SERVICE LETTER

No. 362B

Modification of Windshield Top Attachment

Service Letter No. 362B

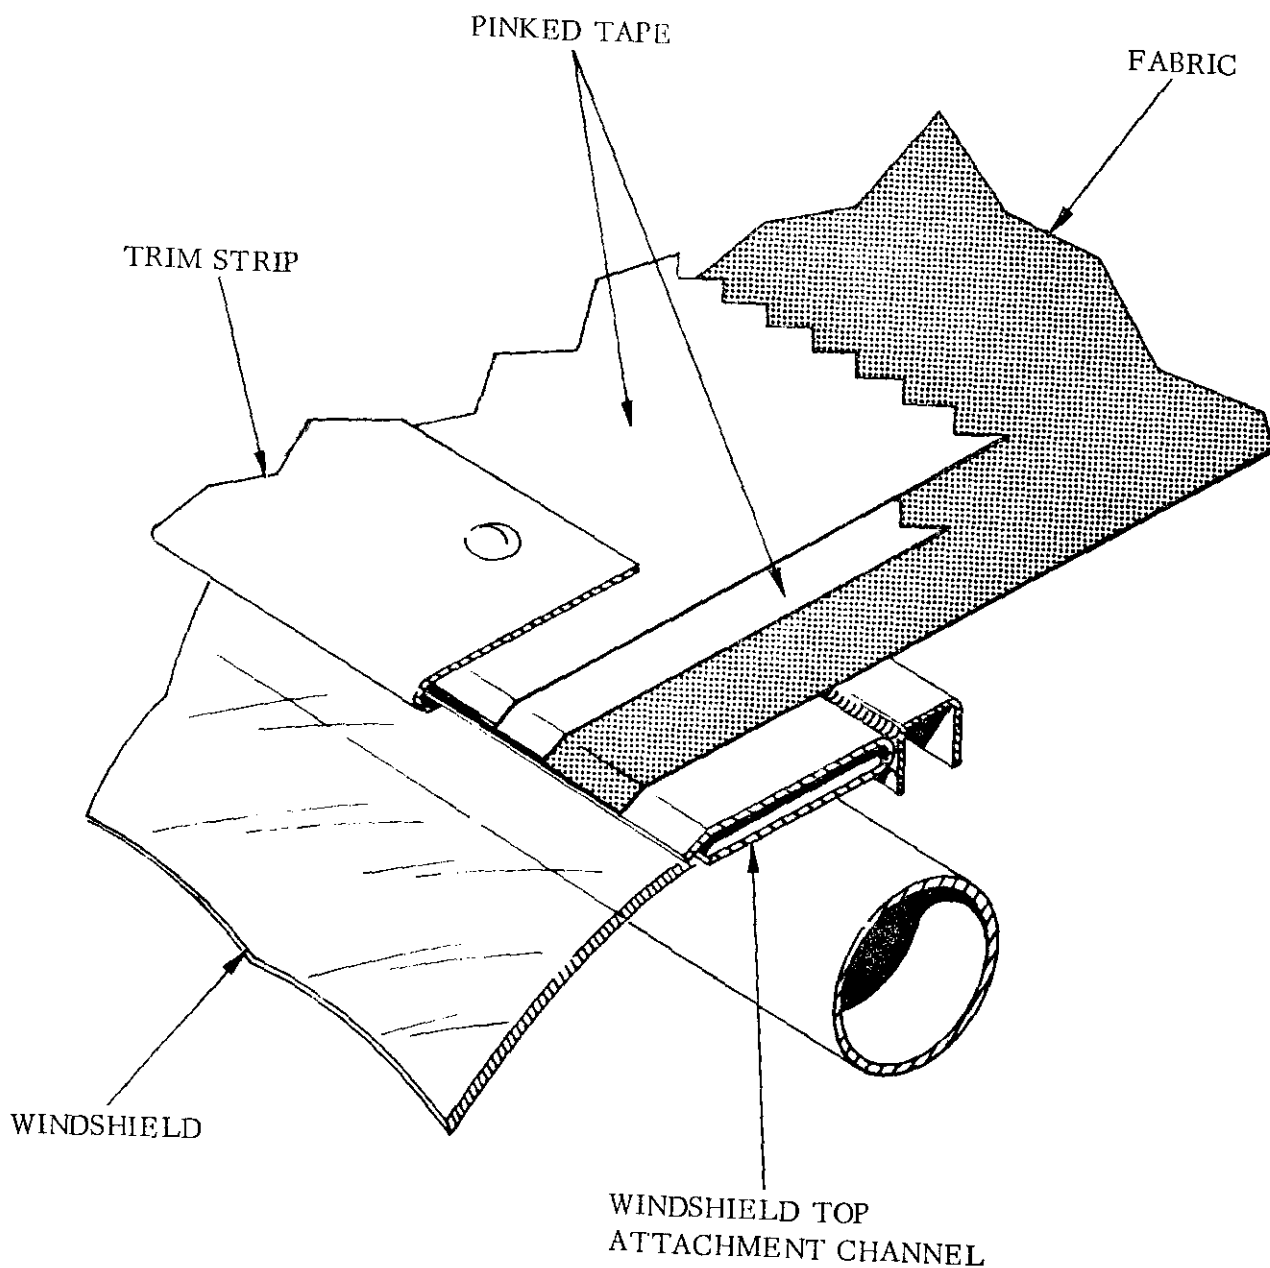
To provide material and instructions to reinforce the area where the fabric attaches to the fuselage under the windshield top and/or directly over the rear edge of the windshield top attachment channel on the above referenced aircraft. The attached sketch illustrates this area.

Contained in Fuselage Fabric Trim Strip Installation Kits, Piper part numbers 754 404 and 760 799 (reference Material Required, below).

1. Applies to PA-15, PA-16, PA-17 and PA-20 aircraft listed above, and PA-22 aircraft serial numbers 22-1 to 22-7630 incl.: One (1) each per aircraft Fuselage Fabric Trim Strip Installation Kit, Piper part number 754 404, at \$2 suggested unit retail price.
2. Applies to PA-12 and PA-14 aircraft listed above: One (1) each per aircraft Fuselage Fabric Trim Strip Installation Kit, Piper part number 760 799, at \$4.58C suggested unit retail price.
